Memorandum

To	Anglicare	Daniel Jukic	daniel.jukic@anglicare.org.au
From	Joshua Bendit	Date	25 Jun 2018
Subject	Review of Geotechnical Report 9-15 Northumberland Street, Liverpool	Project No.	86455.01

Figure 1 – extract from geological mapping

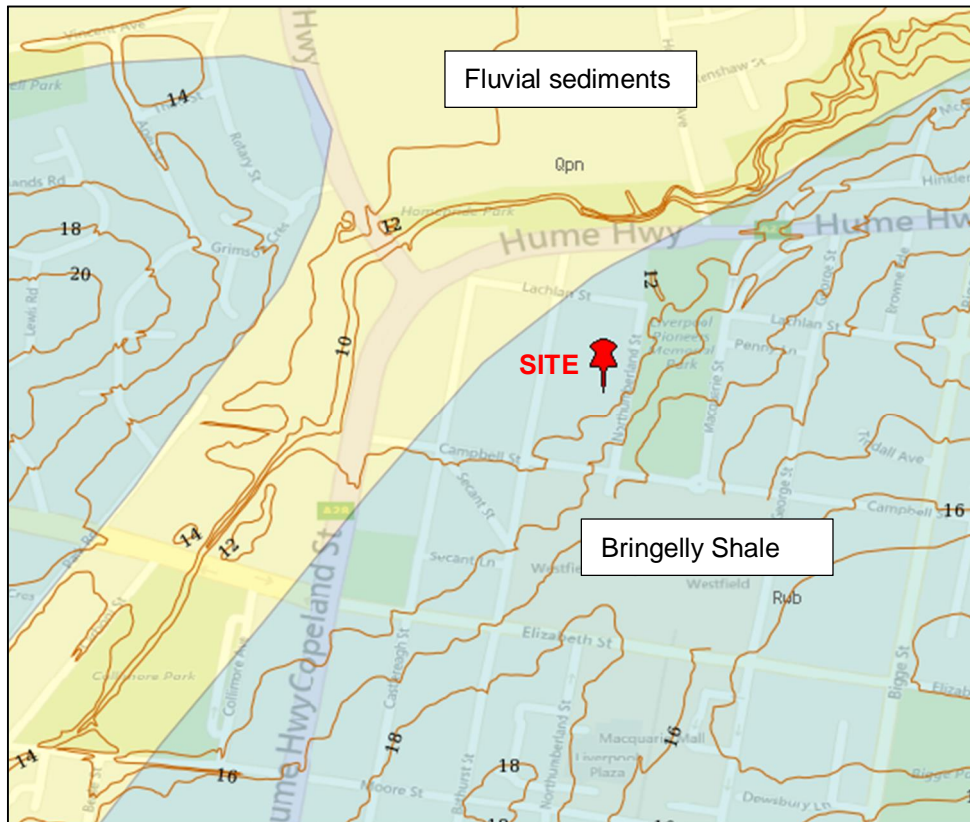
1. DP has carried out investigations on nearby sites including the Westfield Shopping Centre to the south of the site. The DP investigations at Westfield generally encountered shallow residual clay to say 1-3 m depth over rock which is consistent with the geological mapping. The deeper clay profile encountered on the subject site by EI suggests that some of the clay profile may be associated with fluvial sediments, as mapped to the north and west of the site. These sediments can be more variable in strength and consistency and can also include layers of more sandy or granular soil, which if encountered, will have a higher permeability and would be associated with higher inflow rates into the basement. The EI logs and report have not identified any obvious sandy/granular layers, however there is a risk that such layers may be present between the SPT tests. Some of the SPT values in the clays were low (4-8) but the clay was still logged as stiff and very stiff. Cone penetration tests (CPTs) and possibly additional boreholes could be used to check and provide more detail on the consistency of the soil profile, if required for detailed design.
